**REPAIR OF THE AL GHAZALIYAH
G-7 SEWAGE LIFT STATION**

**SIGIR PA-07-118
JANUARY 25, 2008**

SUBJECT: Report on Repair of the Al Ghazaliyah G-7 Sewage Lift Station in Baghdad,
Iraq (Report Number SIGIR PA-07-118)

Site Photos 6 and 7. View of pool of accumulated sewage water outside the G-7 lift station

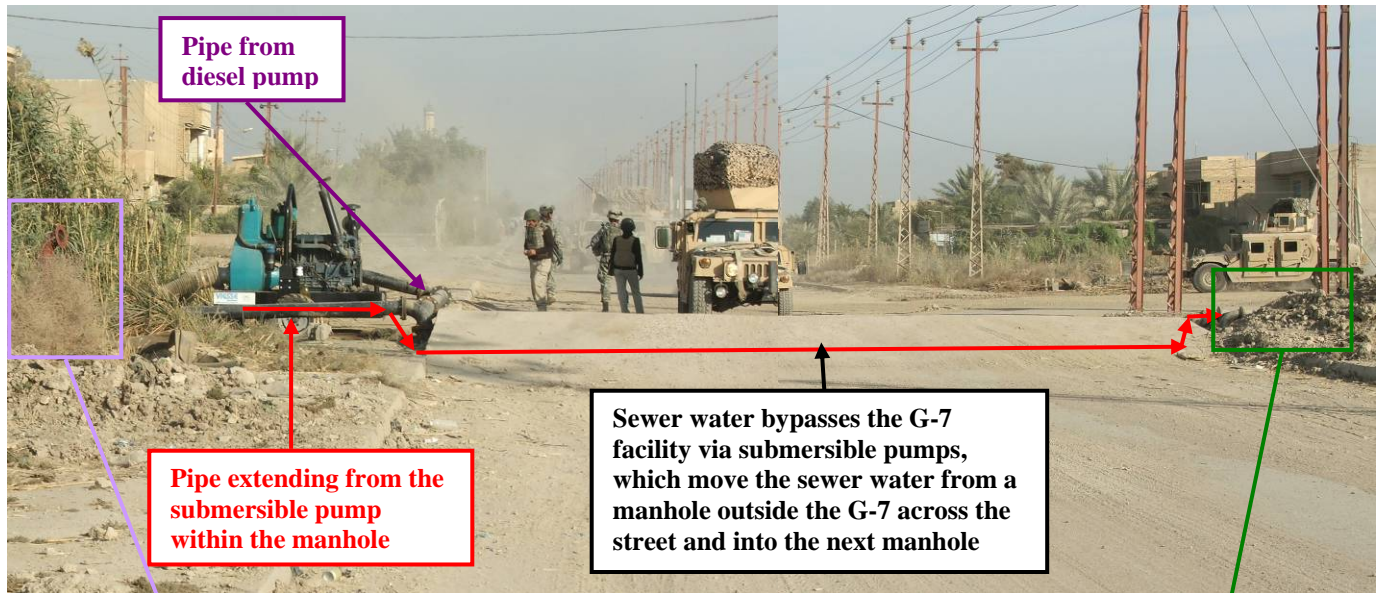
Inspectors also viewed a large pool of collected sewer water outside the sewage lift station building (Aerial Image 4 and Site Photos 6 and 7). During our site visit, maneuver unit personnel stated that the sewer pipes leading into the facility were old and broken. Considering the depth of the sewer water pool and the growth of weeds around it, the sewer line was broken for an extended period. However, the SOW did not address the problems with the broken sewer pipes. Without addressing this problem, the completion of this project will not lead to a "complete and useable facility" because the sewer water will not enter the lift station's wet well (to be pumped out to the next manhole).

Site Photo 8. View of bypass system employed to allow sewer water to flow to the next available manhole

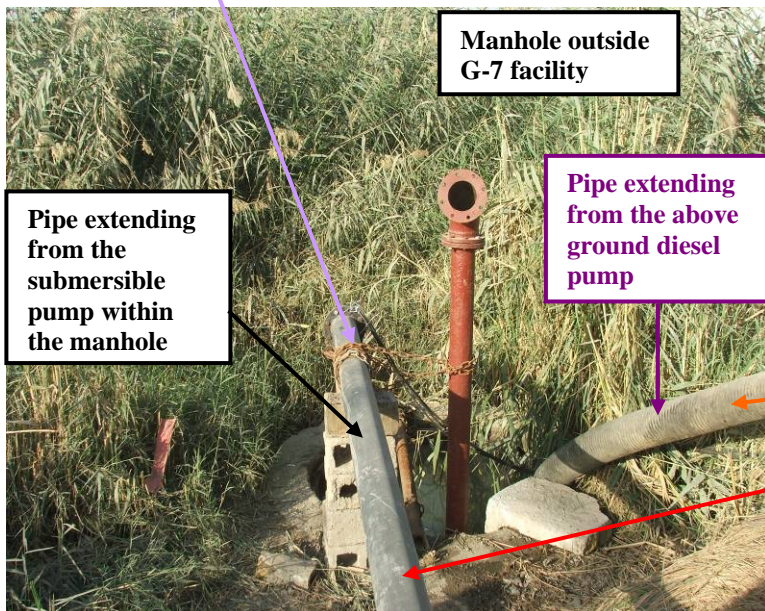
During our site visit, inspectors noticed two pipes exiting a manhole outside the lift station (Site Photo 8). One pipe was attached to an above ground diesel pump; while the other pipe was attached to a submersible pump. The two out-flow pipes rose out of an existing manhole and passed under a concrete hump to cross the street in order to use a higher elevation manhole as an outlet point (Site Photos 9 and 10).

The contract file lacked documentation to explain the need for the submersible pump outside the lift station facility. As previously mentioned in the Project Design and Specifications section, the contractor did not provide design drawings to identify the use of the equipment required by the SOW. However, it appeared the original intent was to use the two submersible pumps either to replace or compliment the two existing submersible pumps inside the facility.

The use of the submersible pump inside the manhole appears to be a short term solution to deal with the large pool of sewer water outside the lift station building. Since the broken sewer pipe does not allow sewer water into the facility, the accumulation of sewer water grew each day. Installing the submersible pump into the wet well of the lift station would not help to alleviate the growing pool of sewer water outside.

Site Photo 13. Submersible pumps located outside the G-7 lift station

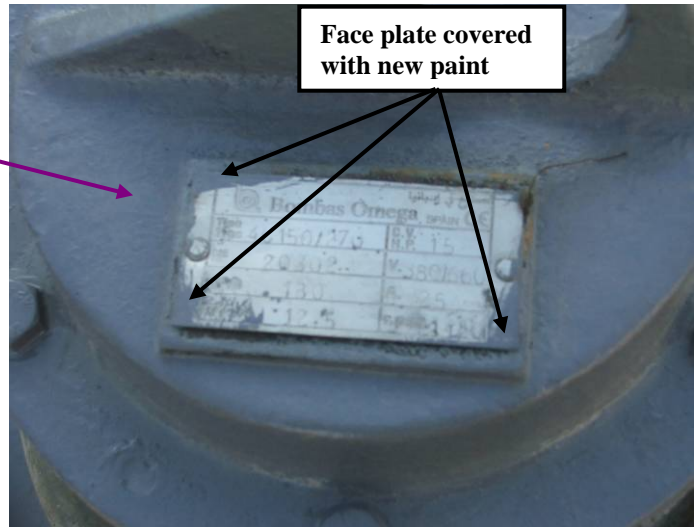
During our second site visit, SIGIR met a member from a military maneuver unit in the area who stated that the back up of sewer water throughout the neighborhood was so pervasive that the local provincial council or the ministry provided equipment for the lift station. SIGIR located multiple submersible pumps on site (Site Photo 13); however, they appeared to be repainted old pumps (Site Photo 14).

Inspectors could not evaluate the installation of the submersible pump because, at the time of our site visit, neither the submersible pump nor the diesel pump was operational.

It is not clear if the submersible pump will remain in the manhole or whether it will eventually be moved into the lift station facility. The use of the submersible pump and the diesel pump to alleviate the sewer water pool has had little effect because inspectors noticed a significant accumulation near the side of the lift station facility.

Site Photo 18. Existing transformer

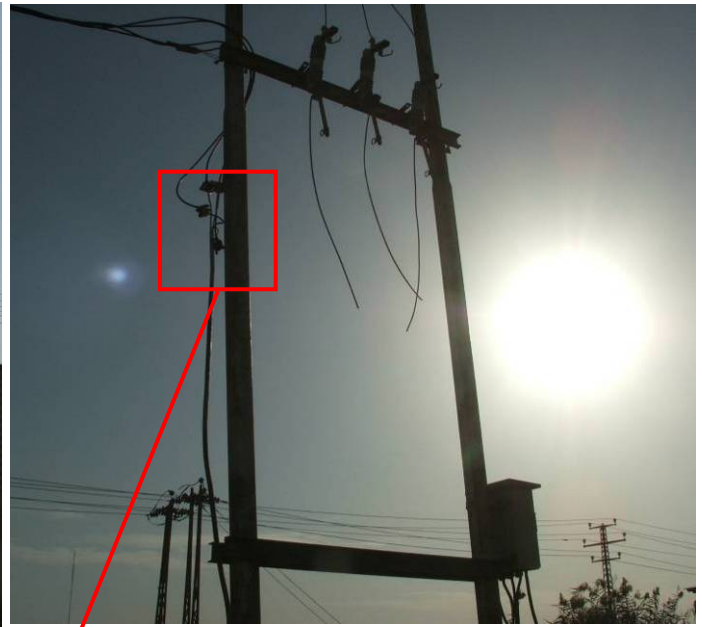
During our first site visit, SIGIR identified the old, non-operational transformer (Site Photo 18). The transformer was subsequently removed and the facility was directly tapped into the main power line by jury-rigging the electrical wires (Site Photo 19). This is an extremely dangerous practice and likely will damage and/or destroy the facility's electrical equipment and controls as well as endanger the safety of the operator. Iraqi main power lines normally carry 400 volts. Without a step-down transformer, turning on the control panel could potentially short circuit the equipment and potentially electrocute

the operator. It is extremely unsafe to have unregulated splices in power cables carrying relatively high voltage since the splices are unsupported and unprotected (Site Photo 20). As a result, it is possible that a loose wire could come free and potentially electrocute someone in the vicinity of the lift station.

The lift station requires a new transformer to take advantage of the electrical grid and also the two on site generators.
